BUILDING PERMIT APPLICATION

Project Address	1501 S. POTOMAC, AURORA, CO		**Unit #**
Project Name:	AT+T SITE: HUMANA (COLO1176)		
Contractor Company Name	HERB QUINTANA	**Phone** 303.915.4556	**Fax** N/A
Contact Person		**Phone**	
Email	HERB@Q3CONSULTING.COM		**Fax**
Architect and/or Engineer Contact information for correction items			
Architect or Engineer name	KEN MCCRACKEN	**Email**	KMCCRACKEN@PMDGINC.COM
Phone	303. 955-9040	**Fax**	N/A
Owner (Required for Certificate of Occupancy) only			
Owner address	1301 S. POTOMAC, AURORA, CO		
Email	N/A		
Valuation / FDA:$	10,000 – NW	**Materials Cost: $**	8,000

Describe The Work You Will Be Doing: SWAP EXISTING BATTERIES IN SHELTER. SWAP 3 EXISTING ANTENNAS ON ROOF. ADD 3 NEW REMOTE RADIO HEADS BEHIND ANTENNAS. Need GC Route to Planning

Subject: Humana (COL01176)
1501 South Potomac
Aurora, CO 80012
Benesch Project Number: 150931.03

Sheet Number
A-2

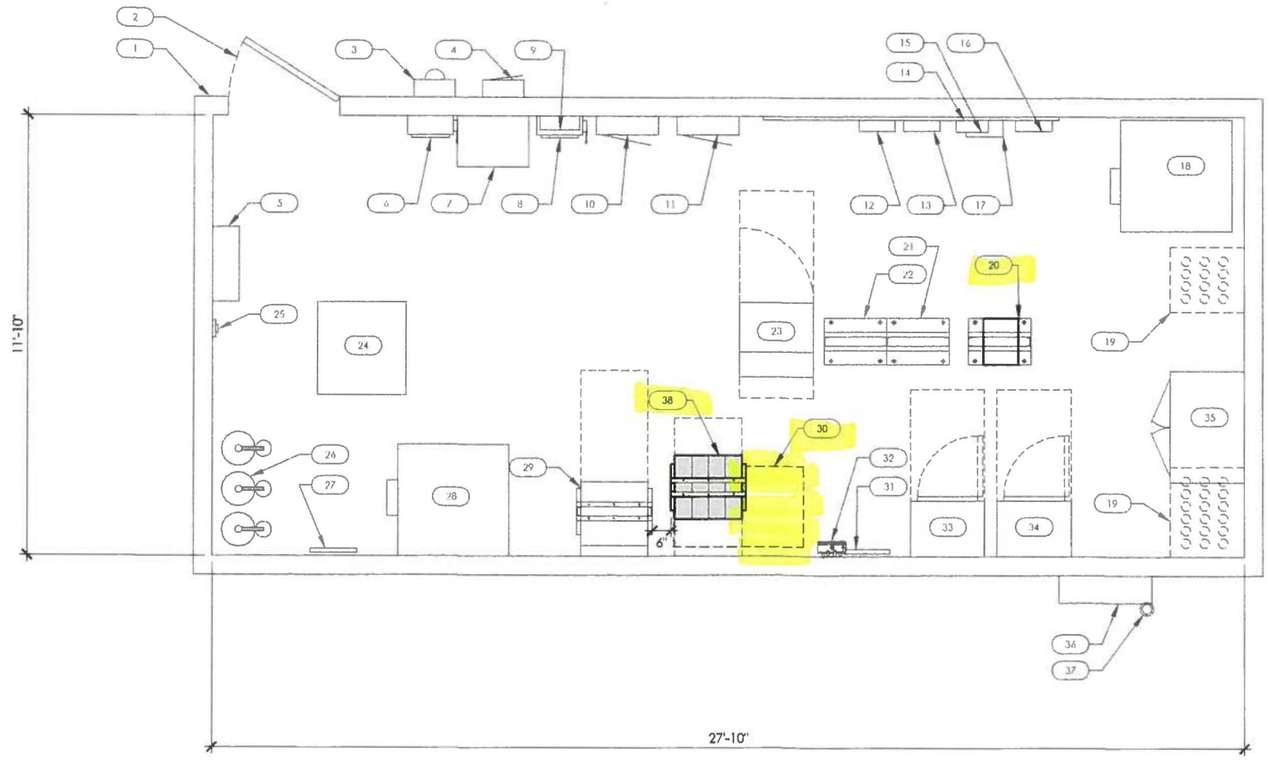
BATTERY ELECTROLYTES LESS THAN 50 GALLONS ← SEE "GNB" SHEET PROVIDED TO VERIFY BATTERY TYPE INSTALLED.

PROVIDE AT&T & FIRE DEPARTMENT APPROVED FIRE EXTINGUISHER IN EQUIPMENT ROOM. ← 2A40BC MINIMUM OR EQUIVALENT

CONTRACTOR TO VERIFY THAT APPROVED SIGN IS PROVIDED AT DOOR INTO EQUIPMENT ROOM. PROVIDE AS NECESSARY.

SIGN SHALL STATE THE FOLLOWING:

1. THE ROOM CONTAINS ENERGIZED BATTERY SYSTEMS.
2. THE ROOM CONTAINS ENERGIZED ELECTRICAL CIRCUITS.
3. THE BATTERY ELECTROLYTE SOLUTIONS, WHERE PRESENT, ARE CORROSIVE LIQUIDS.

CITY OF AURORA
BUILDING DIVISION
APPROVED AS NOTED FIRE/LIFE-SAFETY <50 gallons
DATE 5/14/15
15-942571-LT
RSN 991193
